Access Compliance Report

Public Rights-of-Way

(Curb Ramps)

Intersection ID: 3336	Main Street: BARRISTER_WY	Cross Street: MT_HOLLY-HUNTERSVILLE_RD	Location:	N/A
ADA ID: 6231ABCCF21B	Ramp Type: Perp	Initial Pass/Fail: Fail	Overall Compliance: No	Severity Score: 13.75
Codes/Mitigation Info/Possible Solution		Field Measurements/Component Compliance

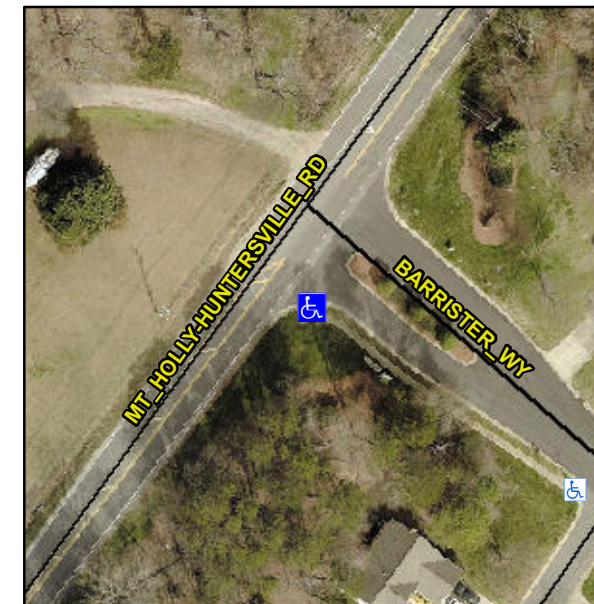
Not Found, R304.2.2

Compliance	Description	Data	Compliance	Description	Data
N/A	Ramp Length (in)	47.0	No	Ramp Slope (%)	8.9
Yes	Ramp Width (in)	49.0	Yes	Ramp XSlope (%)	2.1
N/A	Flare Type LT	N/A	N/A	Flare Type RT	N/A
N/A	Flare Slope LT (%)	N/A	N/A	Flare Slope RT (%)	N/A
N/A	Flare Traversable LT?	N/A	N/A	Flare Traversable RT?	N/A
N/A	Landing Length (in)	N/A	N/A	DWS Provided?	N/A
N/A	Landing Width (in)	N/A	N/A	DWS Contrast?	N/A
N/A	Landing Slope (%)	N/A	N/A	DWS Length (in)	N/A
N/A	Landing X Slope (%)	N/A	N/A	DWS Full Width?	N/A
N/A	Landing Curb? (Y/N)	N/A	N/A	DWS Offset (in)	N/A
N/A	Shared Landing?	N/A			
N/A	Gutter Ponding?	N/A	N/A	Gutter Slope (%)	N/A
N/A	Gutter Lip Ht (in)	N/A	N/A	Gutter X Slope (%)	N/A
N/A	Painted X Walk1?	No	N/A	Painted X Walk2?	N/A
	X Walk 1 Direction	To NW		X Walk 2 Direction	N/A
N/A	X Walk 1 Width (in)	N/A	N/A	X Walk 2 Width (in)	N/A
	X Walk 1 Slope (%)	0.4		X Walk 2 Slope (%)	N/A
	X Walk 1 X Slope (%)	5.4		X Walk 2 X Slope (%)	N/A

Remove & Replace Entire Ramp.
